# Planning and Zoning Commission

## Bright Road Reserve 25-079FDP, 25-081FP

Address	North of the intersection of Grandee Cliffs Drive and Bright Road
Proposal	Development of a residential neighborhood consisting of 20 single-family lots on a 14.2-acre site.
Request	Review and approval for a Final Development Plan and Final Plat under the provisions of Zoning Code Section 153.066 and the Subdivision Regulations.
Zoning	Planned Unit Development District (PUD) - Bright Road Reserve
Planning Recommendation	<u>Approval of the Final Development Plan with Conditions and Text Modifications</u> <u>Recommendation of Approval for the Final Plat with Condition</u>
Next Steps	Upon approval of the Final Development Plan and City Council approval of the Final Plat, the applicant may apply for site and building permits.
Applicant	Curtis Echelberry, Advanced Civil Design
Case Manager	Rati Singh, Assoc. AIA, Planner II (614) 410-4533 <a href="mailto:rsingh@dublin.oh.us">rsingh@dublin.oh.us</a>

Site Plan

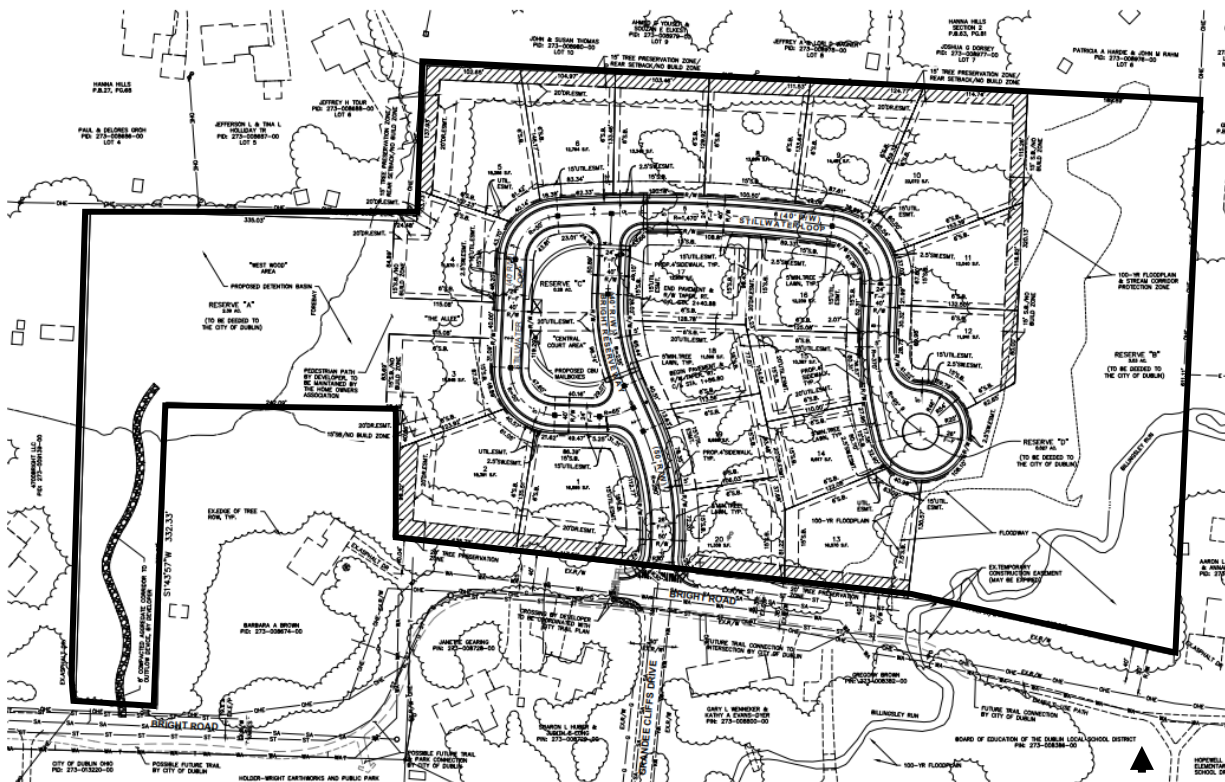
Final Development Plan	
Criteria	Review
1. The plan conforms in all pertinent aspects to the approved preliminary development plan.	<b>Criterion Met with Text Modification:</b> The FDP is largely consistent with the requirements of the Zoning Code and Bright Road Reserve PDP. Due to easement locations, development text modification is required to permit an increased minimum setback to principal structure for Lot 1, 2, 5-10 in order to achieve minimum private open space and meet NDG requirement.

Criteria	Review
2. Adequate provision is made for safe and efficient pedestrian and vehicular circulations within the site and to the adjacent property.	<b>Criterion Met with Condition:</b> The proposal provides safe pedestrian and vehicular connections throughout the entire site. A future pedestrian crosswalk will connect the development with the public Shared Use Path, which is addressed through a condition of approval.

Criteria	Review
8. Adequate provision is made for storm drainage within and through the site which complies with the applicable regulations in the Code and any other design criteria established by the City or any other government entity which may have jurisdiction over such matters.	<b>Criterion Met with Condition:</b> The applicant should continue to work with Engineering to demonstrate stormwater management compliance to the satisfaction of the City Engineer in accordance with Chapter 53 of the City of Dublin Code of Ordinances.

- 1) The applicant coordinate with the implementation schedule of the City Trail Plan and install a pedestrian crossing when the Shared Use Path is extended along the south side of Bright Road.
- 2) The applicant continue to work with Engineering to demonstrate stormwater management compliance to the satisfaction of the City Engineer in accordance with Chapter 53 of the City of Dublin Code of Ordinances, including modifications to the proposed major flood routing design.
- 3) The applicant correct any waterway deficiencies within Reserve B, identified by the City through inspections, to the satisfaction of the City Engineer.
